SERVICE BULLETIN

**NACELLE — EXHAUST — VENT, COOLING, SLAVE BOOSTER STAGE BLEED VALVE
ACTUATOR (BSBVA) COOLING VENT, RIGHT THRUST REVERSER HALF — ADDITION OF
FOR COOLING AND COMMONALITY ACROSS ALL A320/A321/A319-A5 AIRCRAFT**

April 27, 1998

V2500-NAC-78-0127

Right Thrust Reverser Half Modification
Figure 1 (Sheet 1)

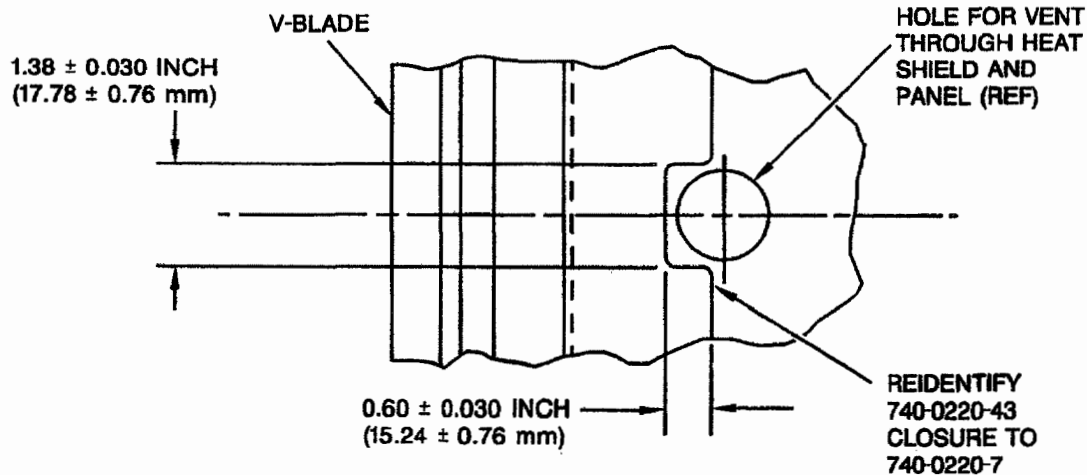
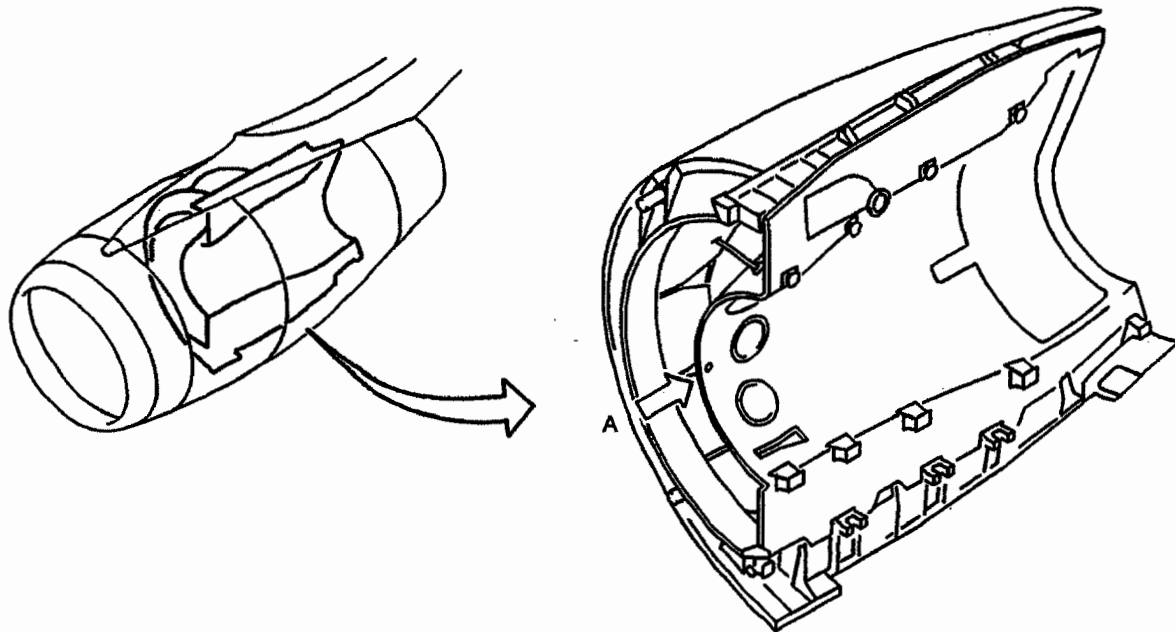
The change introduced by this Bulletin is to make a vent hole and install a vent in the right thrust reverser half fixed structure.

- (1) Make a mark at the position for the 740-0550-503 vent on the right thrust reverser half as shown in Figure 1.
 - (a) Remove the filler from the lower edge of the blocker door fitting.

- (b) Put a straight against the bottom edge of the blocker door fitting and make a mark where the straight edge meets the forward edge of the v-blade.

- (c) Measure up 2.27 inches (57.66mm) from the mark made in (b) and make a mark on the forward edge of the v-blade.
 - (d) Perpendicular to the forward edge of the v-blade, from the mark made in (c), measure aft 4.10-4.20 inches (104.1-106.7mm) and make a mark on the panel.

- (2) Use a No. 40 or smaller drill to drill a pilot hole through the panel and the heat shield. Hold a backup plate against the heat shield while you drill the hole to prevent damage to the heatshield. Make sure you drill the hole perpendicular to the surface of the panel.

- (4) Cut a 1.60 ± 0.030 inch (40.64 ± 0.76 mm) diameter hole through both sides of the heatshield and the filler. Center the hole on the pilot hole drilled in step (2).

Right Thrust Reverser Half Modification
Figure 1 (Sheet 2)

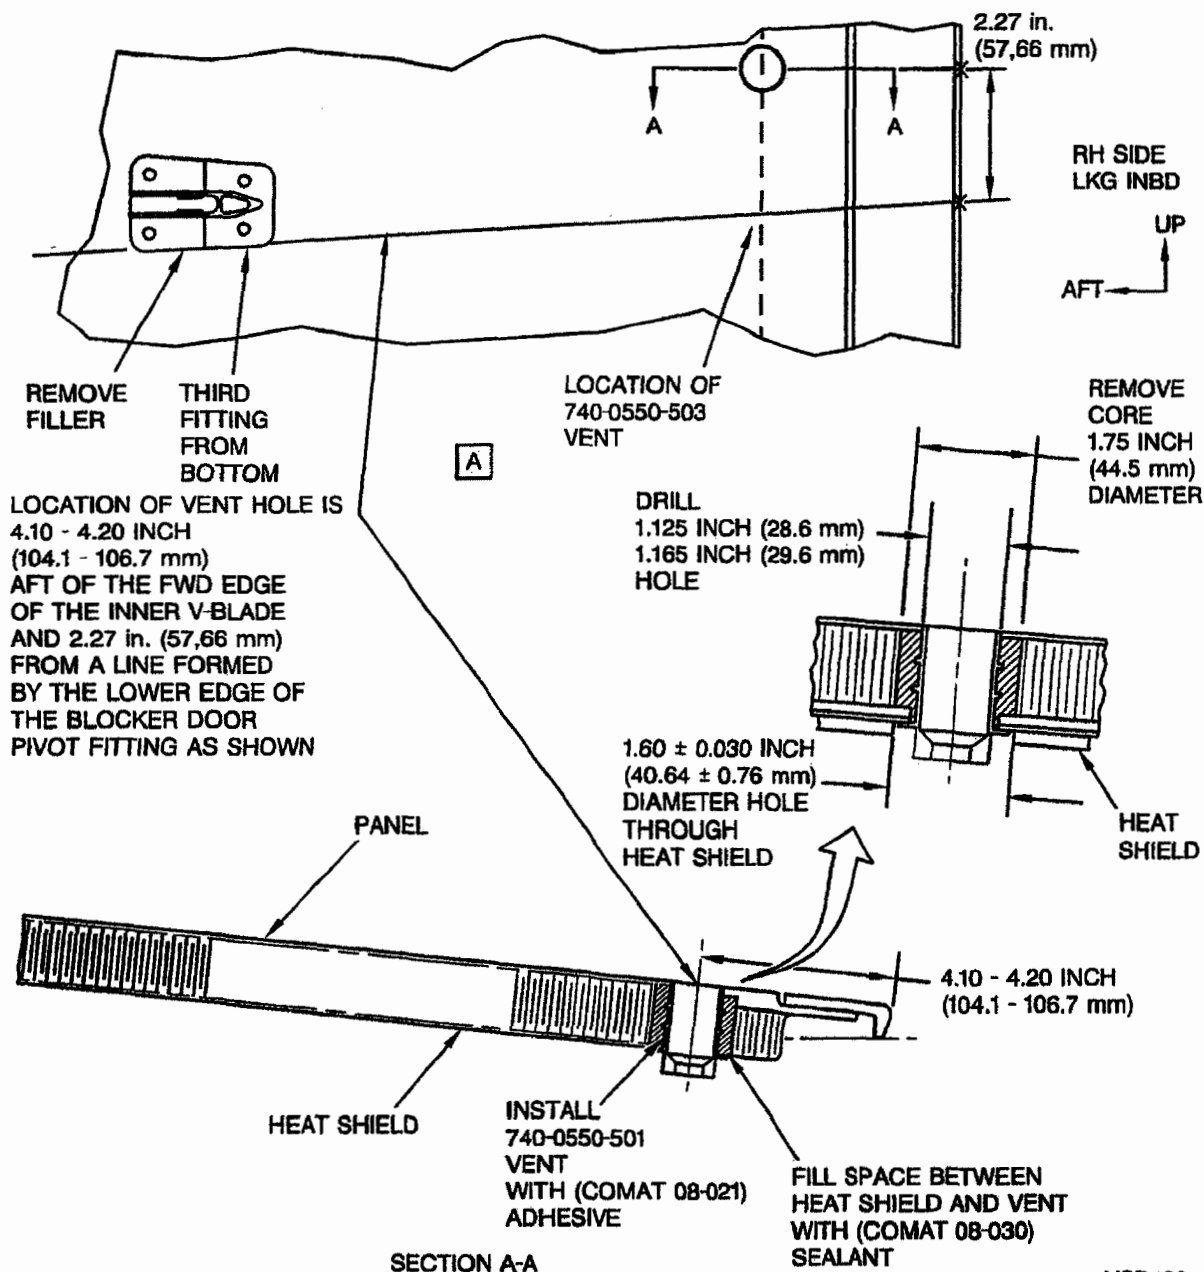
- (3) Remove material from the closure as shown in Figure 1 (sheet 2). Put a piece of metal between the closure and the heat shield to prevent damage to the heat shield.
